**HISTORIC PRESERVATION COMMISSION
OCTOBER 22, 2020
ASSEMBLY HALL
395 MAGNOLIA RD.
PINEHURST, NORTH CAROLINA
4:00 PM**

To: Historic Preservation Commission
From: Peter Hughes, Senior Planner
CC: Darryn Burich, Planning and Inspections Director
Kelly Brown, Administrative Specialist
Date: October 15, 2020
Subject: Major COA Request for 30 Caddell Road

To: Historic Preservation Commission
From: Peter Hughes, Senior Planner
CC: Darryn Burich, Planning and Inspections Director
Kelly Brown, Administrative Specialist
Date: October 15, 2020
Subject: Major COA Request for 100 Fields Road (COA-2020-00056)

MODIFIED GARAGE PLAN

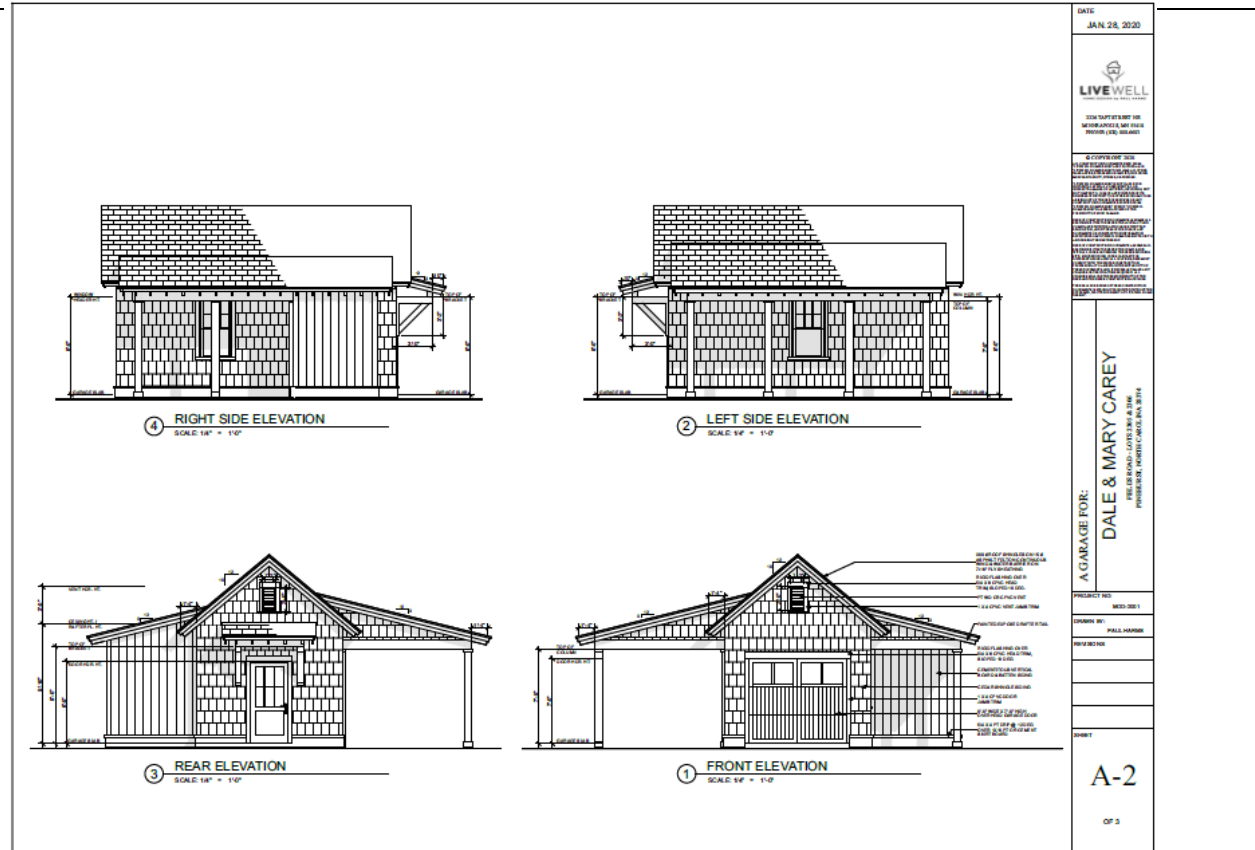
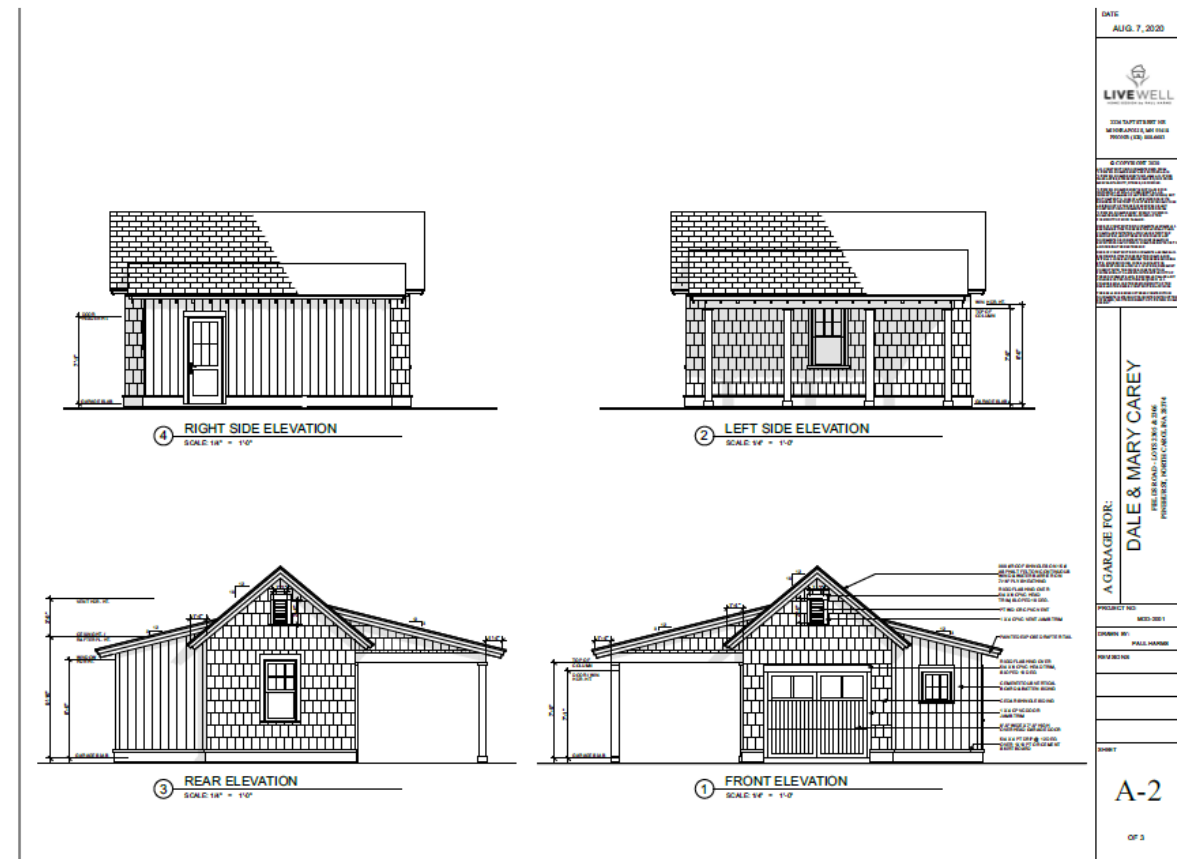
The applicant Pinehurst Homes is request multiple modification to a previously approved accessory structure:

1. Right side elevation – enclose golf cart carport, addition of siding, and addition of a entry door
2. Rear elevation – replace proposed door with window
3. Front elevation – add a window

1. The applicant has submitted a material package which includes: proposed elevations, site plan, and previously approved COA.
2. The applicant has intends to match the material previously approved.
3. There is no change to the footprint of the structure.
4. *There is no change to the location of the accessory structure.*
5. *The proposed accessory structure does not exceed 30 percent of the floor area of the principal structure (PDO requirement).*
6. The applicant is not proposing any changes to the color scheme
